VILLAGE OF GERMANTOWN
N112 W17001 MEQUON ROAD, GERMANTOWN, WI 53022

MEETING:	PLAN COMMISSION
DATE AND TIME:	MONDAY, October 14, 2019 6:30 p.m.
LOCATION:	Germantown Village Hall Board Room

**CERTIFIED SURVEY MAP (CSM),
CONDITIONAL USE PERMIT & SITE PLAN APPLICATIONS**
10/14/19 Plan Commission Meeting

Village Planner Report

**SITE PLAN -
DETAILED NORTH**

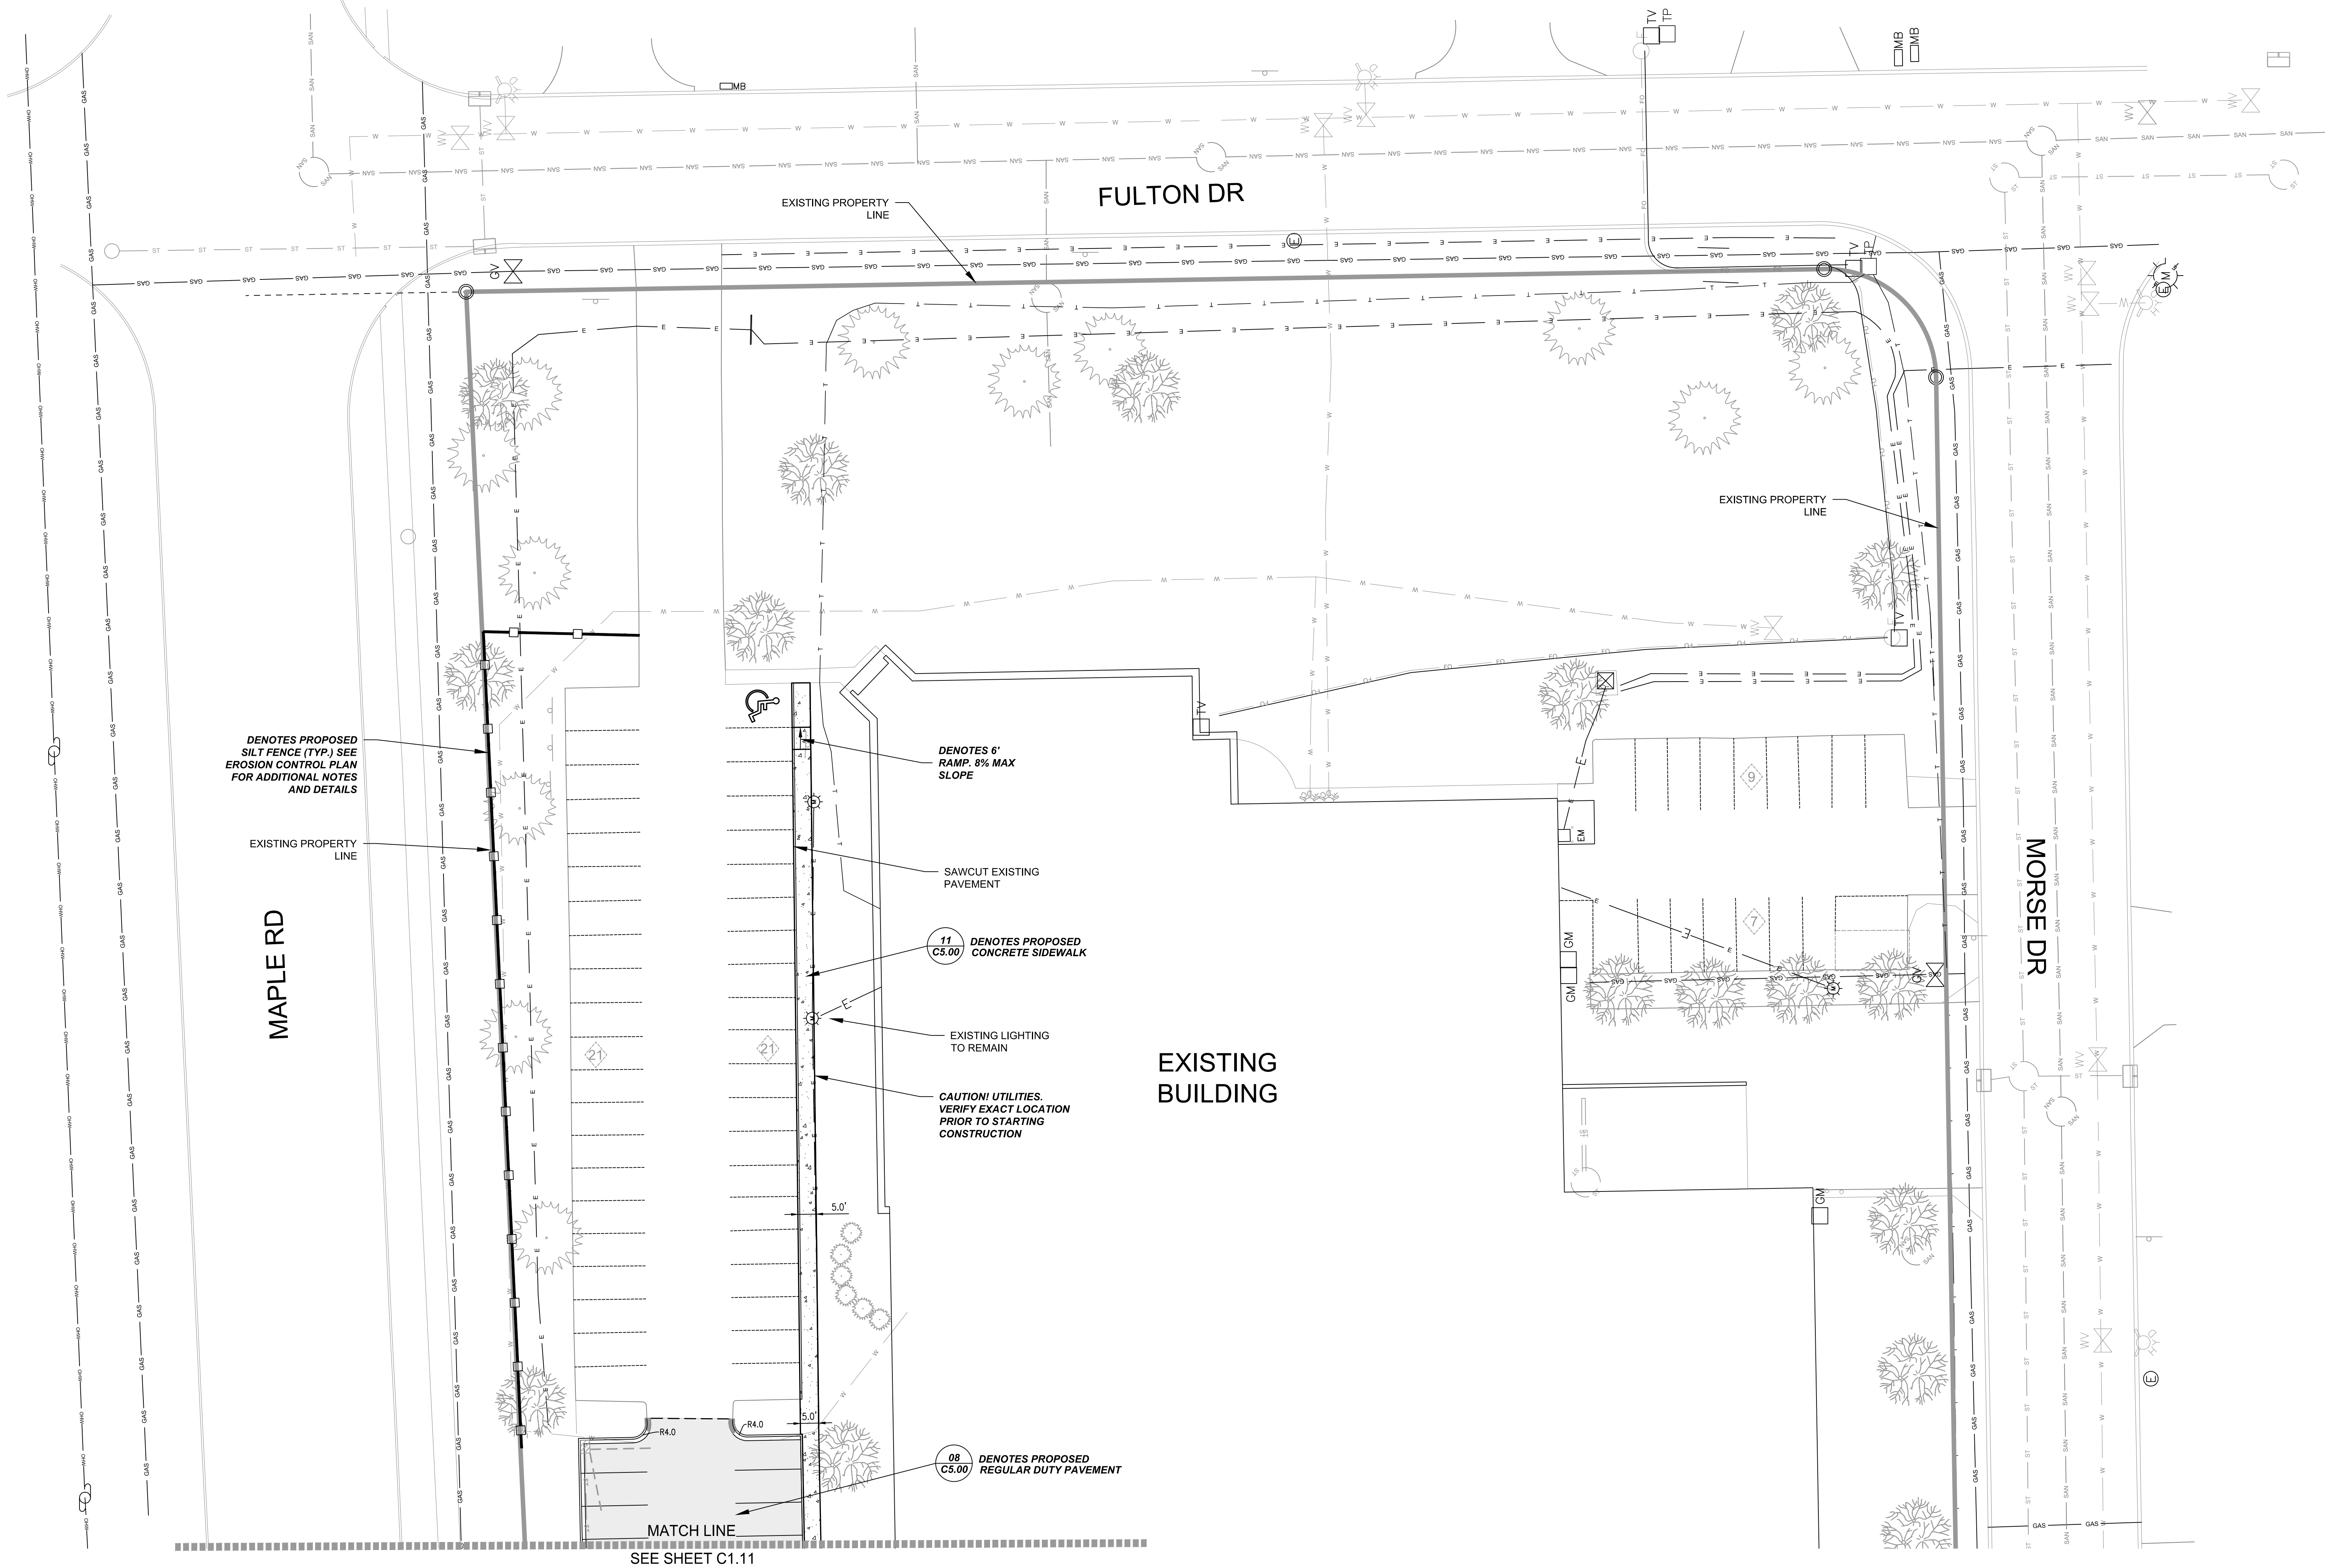
2. It is important to note that the access onto Maple Road is to be right-in and right-out. Thank you for formally calling out the sign on Sheet C1.11.

35 ARCHITECTURAL SITE PLAN

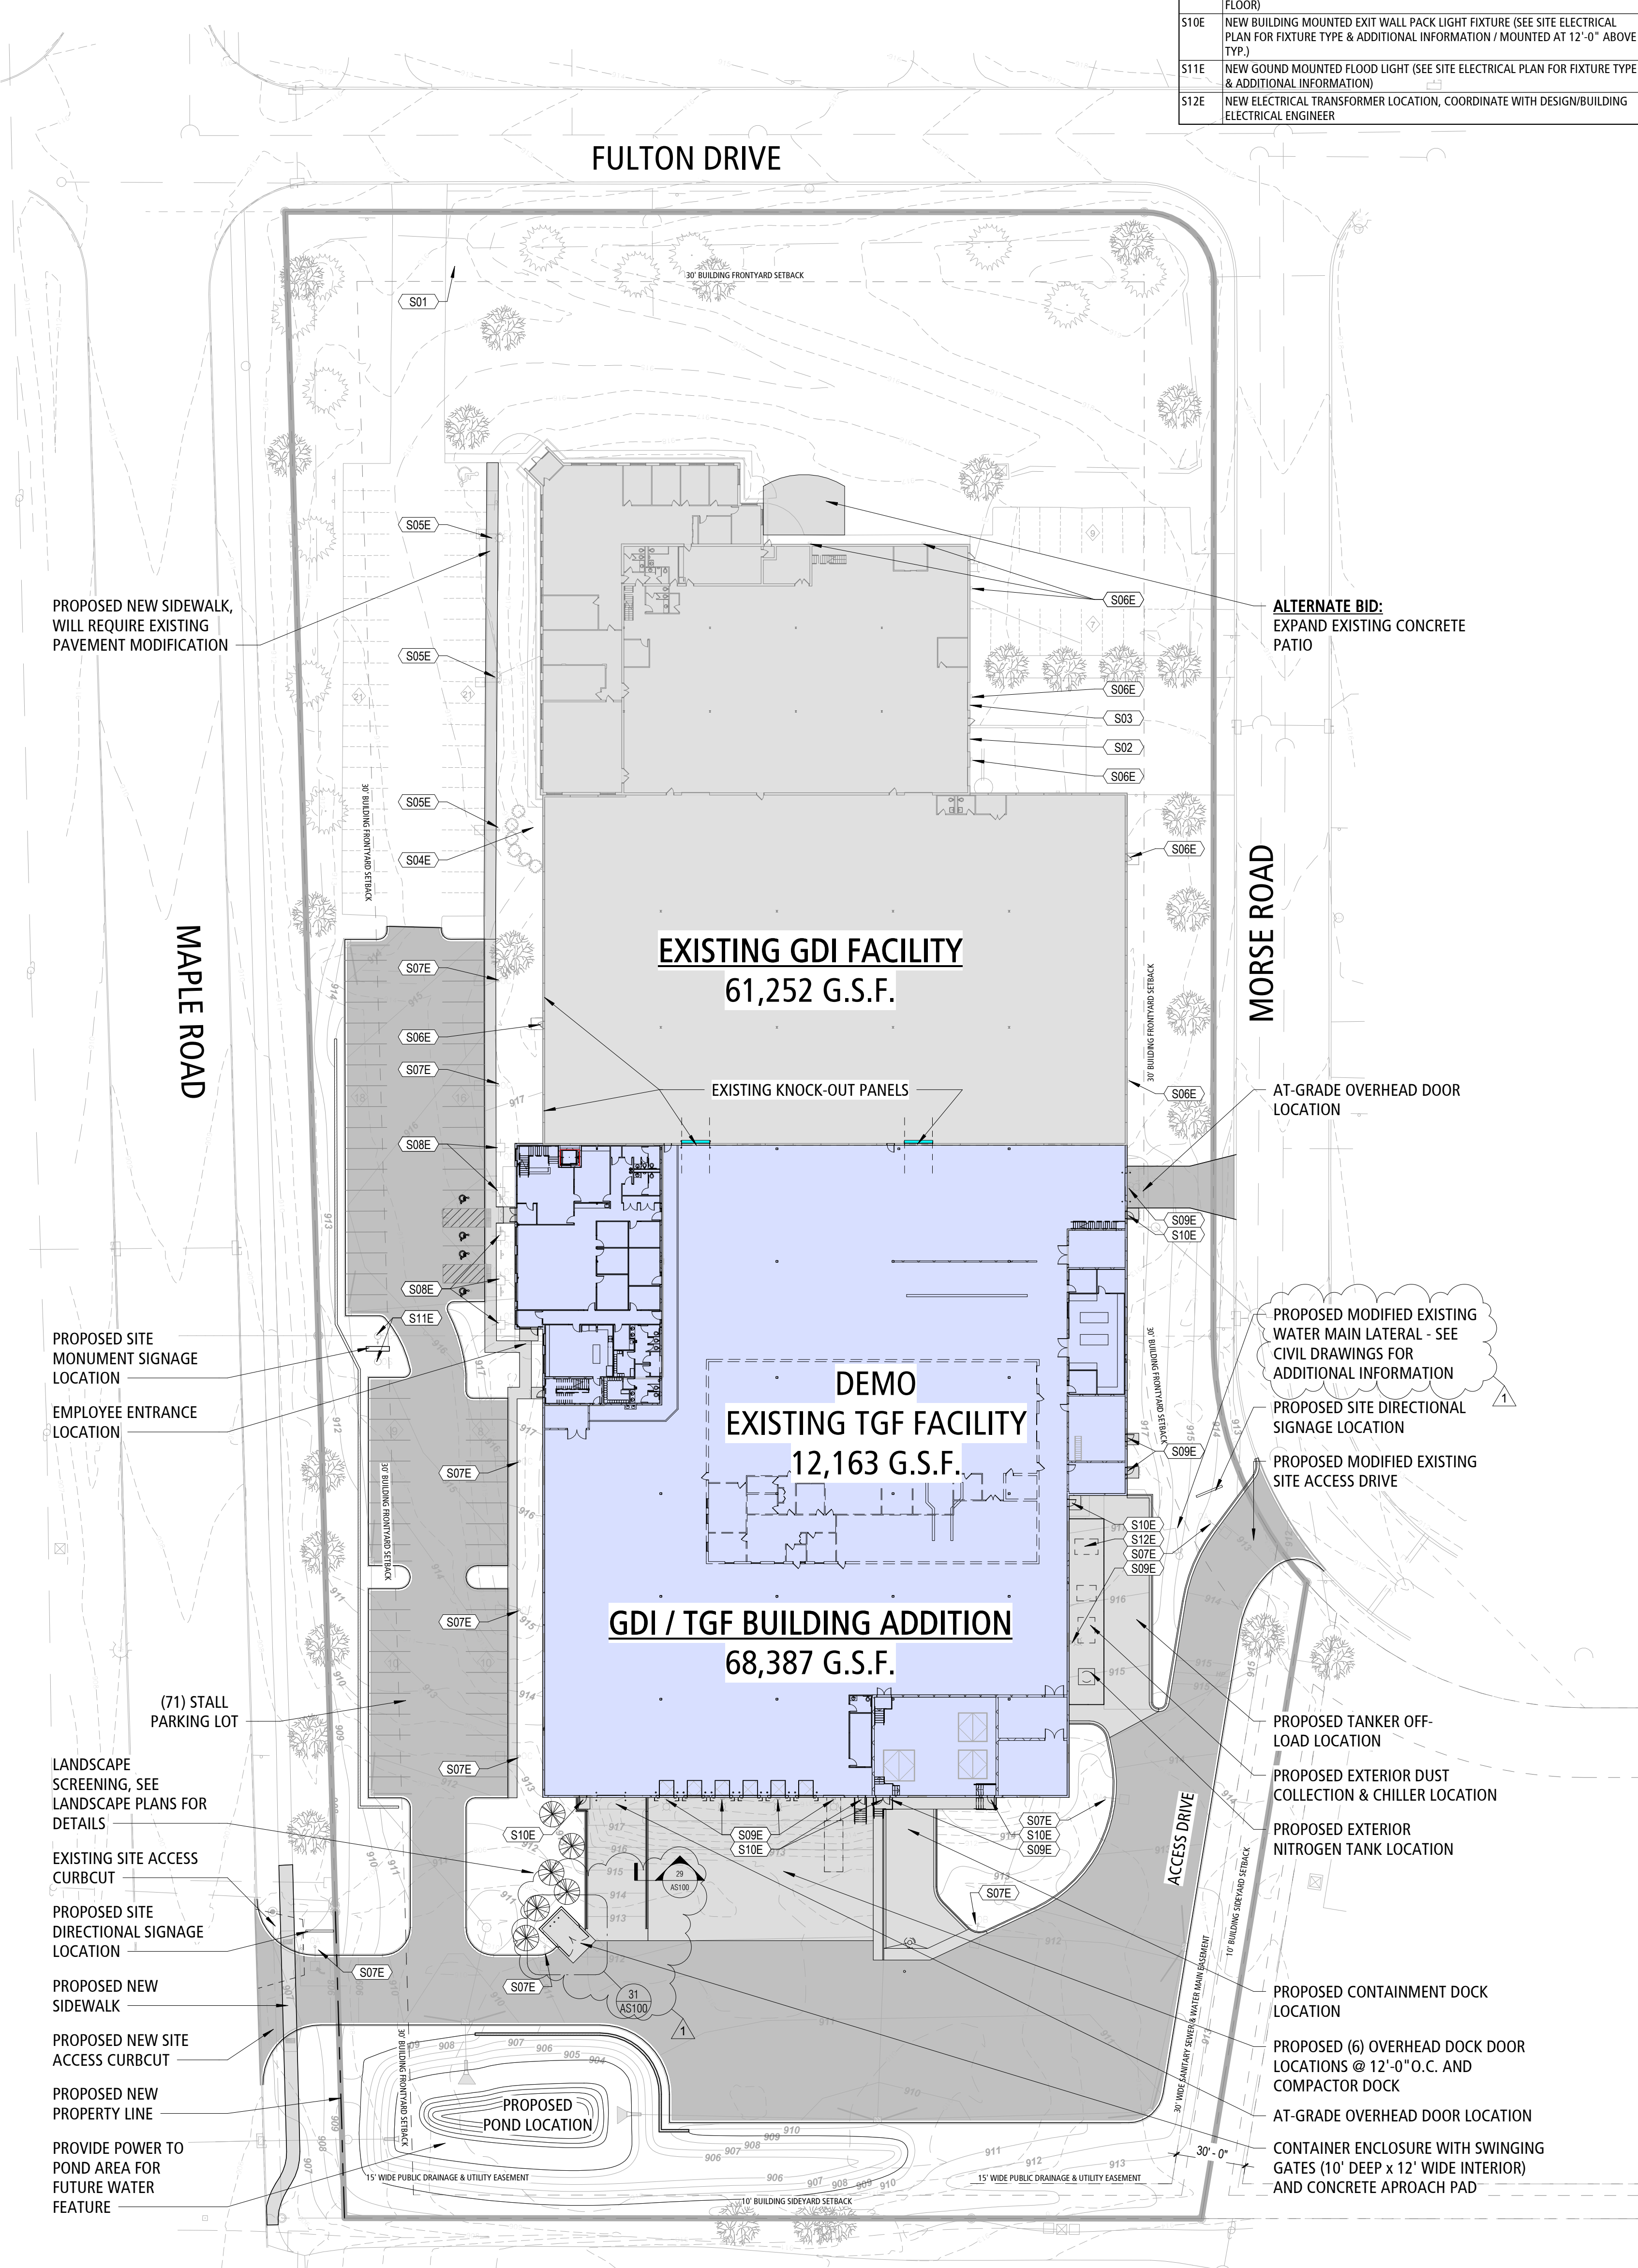
1. On Sheet AS100-Architectural site plan, if the water lateral to this building is not being reused it needs to show abandonment of the water lateral to this building at the water main connection per our abandonment code section.
